RBG-46478

September 21, 2005

Subject: River Bend Station
Docket Nos. 50-458 and 72-49
License No. NPF-47
Revised License Amendment Request (LAR) 2004-26, "Use of the Fuel Building
Cask Handling Crane for Dry Spent Fuel Cask Loading Operations"

RAI from Plant Systems Group

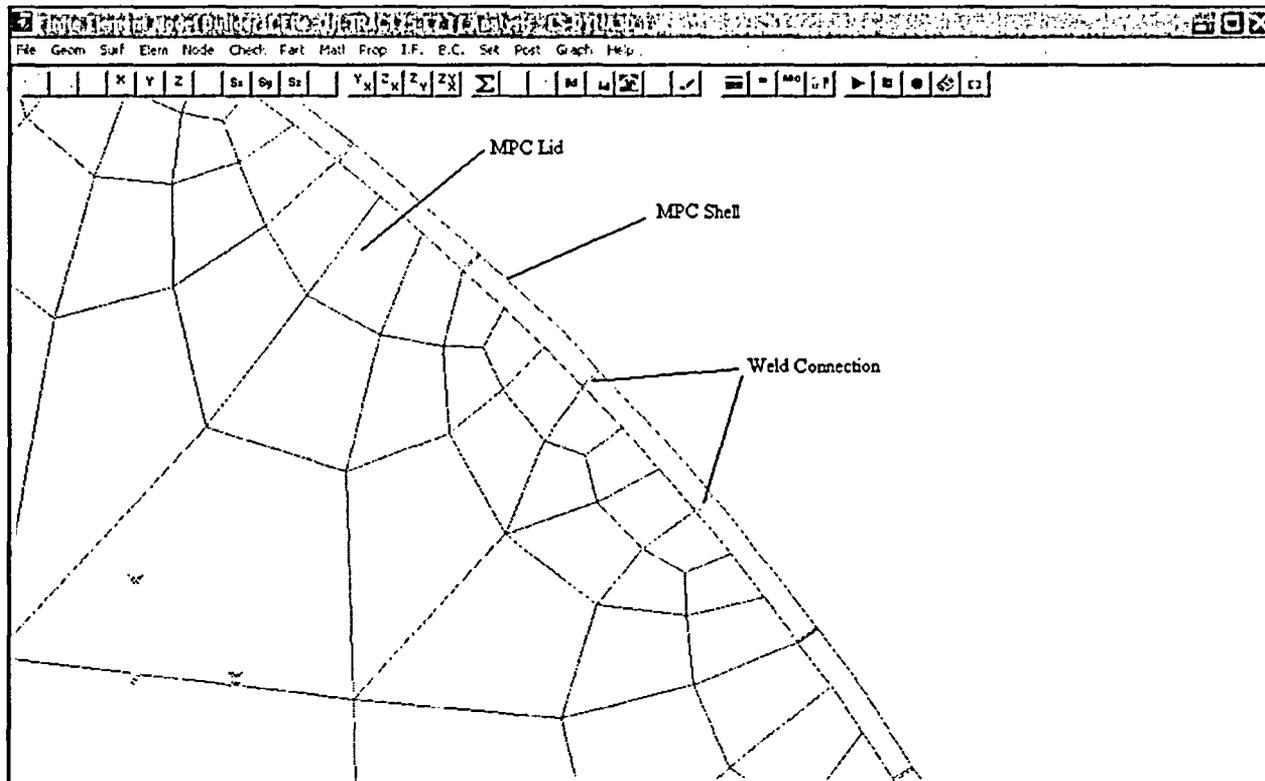
Basis. In Figure 9 of the report, the lid-to-shell weld is shown to be subject to material yielding while the lower shell near the bottom plate of the MPC remains elastic, for a 7" vertical drop of the loaded transfer cask. In a separate calculation package for the MPC subject to a 25-ft drop, the most critically stressed and strained location, however, is shown to be at a lower shell section near the bottom plate. It's unclear whether any modeling anomalies have been introduced to the weld finite element scheme, such as type, size, number of elements, and order of integration for determining stress/strain performance of the weld. Holtec should provide information to show that the weld details are adequately modeled so as not to invalidate the reported stress/strain results.

In the HI-TRAC drop analysis, the MPC lid-to-shell weld joint was modeled by using the LS-DYNA command "*CONSTRAINED_SPOTWELD" at 26 locations around the circumferential weld line of the quarter MPC model with full consideration of the 1/16" gap between the lid and the shell body (a constrained spot weld every 2"). Since the 1/2" thick MPC shell was modeled with shell elements, each pair of constrained shell/lid nodes that represent the local weld connection are distanced 0.625", which is the sum of the lid-to-shell radial gap (1/16") and one half of the shell thickness (1/4"). The following figure shows the weld connection of the LS-DYNA MPC model. The figure shows the top view of the MPC lid (modeled using solid elements), and an end view of the shell (modeled using thin shell elements). It should be pointed out that the HI-STORM FSAR has demonstrated that the MPC lid-to-shell weld joint will not fail as long as the design basis deceleration is not exceeded, which is true for the analyzed 7" drop event.

Because the weld joint is not explicitly modeled with solid or shell elements in the 7" HI-TRAC drop analysis as described above, the Von Mises stress shown in Figure 9 of the

report actually represents the stress status of the MPC shell at the weld connection. The Von Mises stress (i.e., effective stress) combines stresses in two or three dimensions into a single number (a scalar) using the following formula.

As shown in figure 9 of the report, the MPC shell at the shell-to-lid weld connection yields in the analyzed 7" HI-TRAC drop event as a result of the local bending introduced by the small gap between the MPC lid and the shell; the impact does not result in global deformation in the MPC shell. In a separate analysis (documented in HI-2043276) where the MPC directly drops from 25 ft above a rigid target, however, the impact is so severe that the bottom section of MPC buckles immediately as the impact stress wave starts to propagate upward. Dissipating part of impact energy through deformation, the bottom section of the MPC shell acts like an impact limiter that may significantly diminish the otherwise high stresses in the rest of shell above the buckled section. Moreover, the small gap between the MPC lid and the shell may prevent the top section of the shell from being buckled, although the top of shell does experience much greater stress than the 7" drop case.

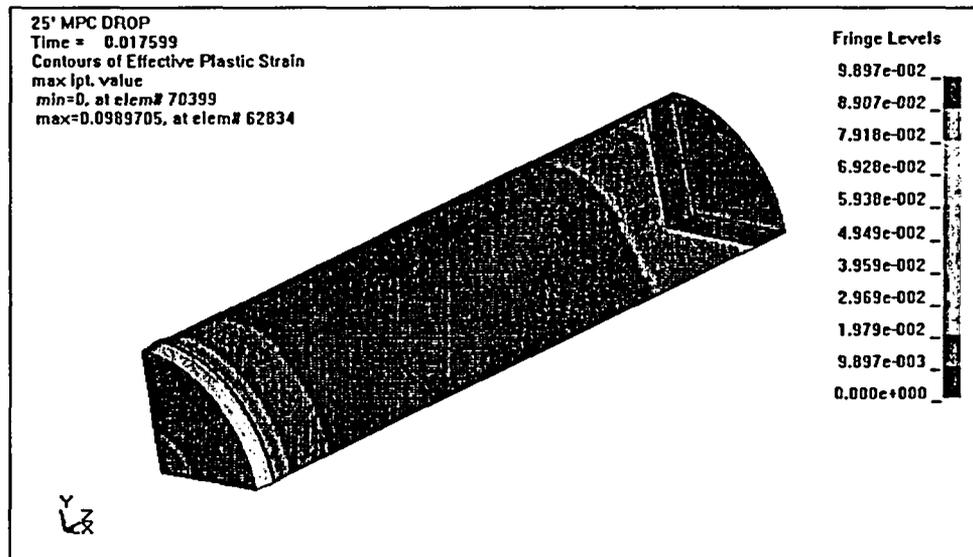
- 3.1 Considering true stress and true strain, perform a supplemental LS-DYNA analysis of the MPC to demonstrate that the strains at the lid-to-shell weld and the lower shell section near the bottom plate remain to be bounded by the material failure strains.

Basis. Contrary to that required by the LS-DYNA to use true stress and true strain in its large-strain computation algorithm, engineering stress-strain relationship appears to have been considered in modeling the elasto-plastic drop analysis of the MPC. The staff notes that the materials at both the top and bottom parts of the MPC are subject to major yielding and resulting stress relaxation at the lid-to-shell weld may affect appreciably the stress state change for the lower shell. Proper account of stress-strain relationship is essential for evaluating maximum strains at critical locations of the MPC.

Nevertheless, a supplemental LS-DYNA analysis has been performed by using the true uniaxial stress-strain relationship presented by the NRC staff in the ASLB hearing to demonstrate the conservatism; the true stress-strain curve shown below was originally obtained by the Sandia National Laboratories.

The following figure shows the plastic strain result from the supplemental LS-DYNA analysis. The maximum plastic strain of the MPC shell (0.09897) is smaller than that reported in Figure 5 of HI-2043276 (i.e., 0.2125) where the engineering stress-strain relationship was used. The plastic strain results comparison confirms that the use of engineering stress strain relationship is conservative for the drop analysis.

Photograph #1

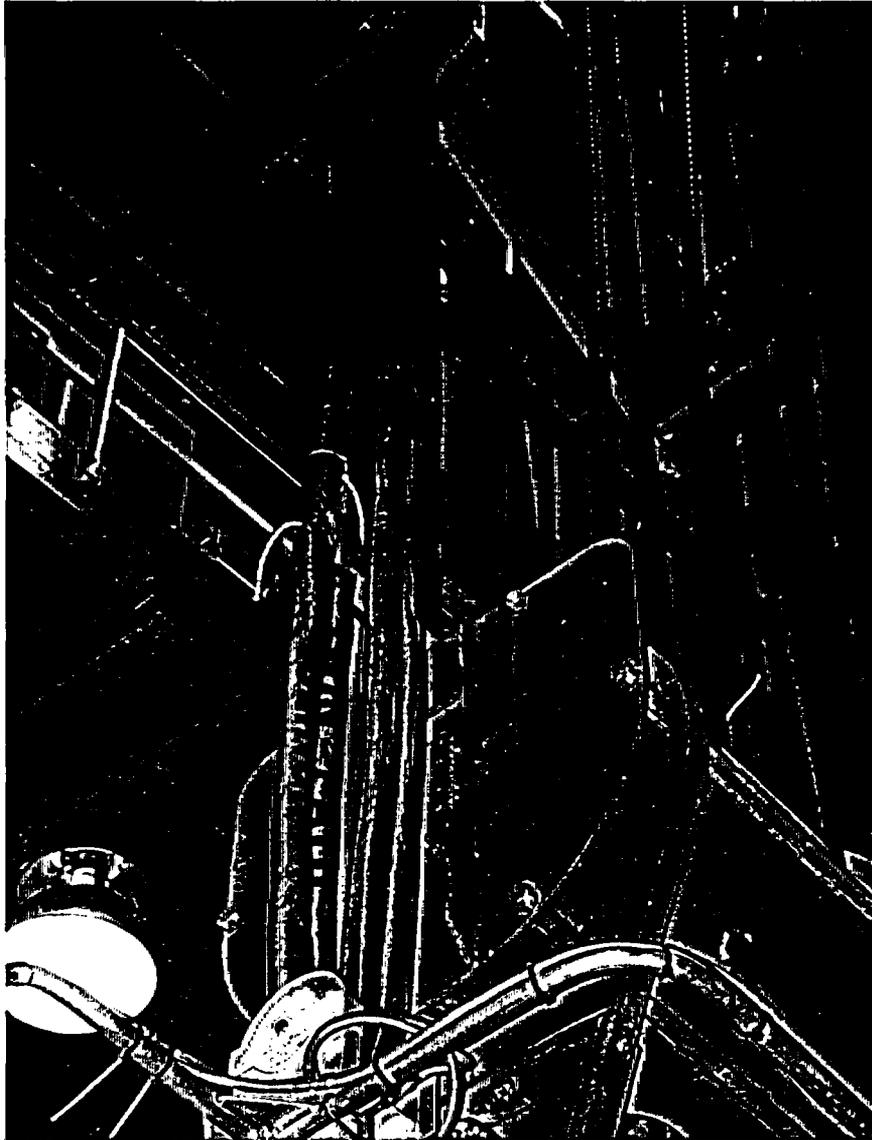
Response:

Beyond the visual observation of the Link Lock engagement in the Lift Yoke opening window, Link Lock engagement is further confirmed by the ability to remove the slack in the redundant slings when the Main Hook is lowered.

The FBCHC Main Hook and attached Lift Yoke have been raised to achieve seating of the Lower Link in the Lift Yoke. Visual observation of the Lower Link top plate's seating on the top of the Lift Yoke Strongback is used to verify that proper seating of the Lower Link in the Lift Yoke. The painted top sides of the Link Locks can be fully seen. The Link Lock has been engaged (pivoted outward into the window in the Lift Yoke Strongback).
